Guarto

**Maintenance Info MI291a
MP3 - Service Release SR2**

Document no. **A6V10235243**
Edition 01.2009

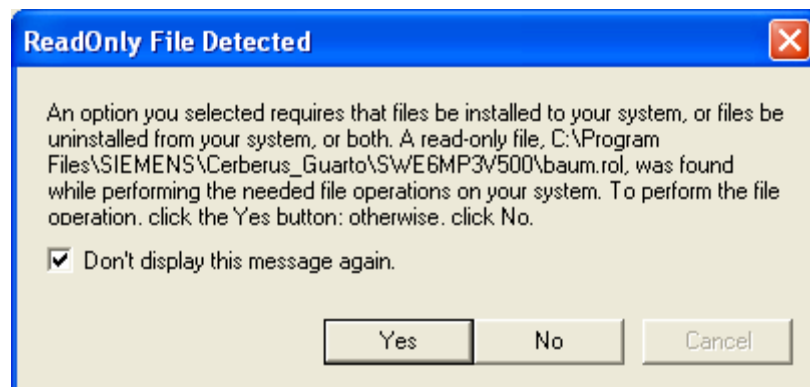
- Uninstall SWE6 MP3 V5.0
- Install SWE6 MP3 V5.0
 - When this message appears: click No
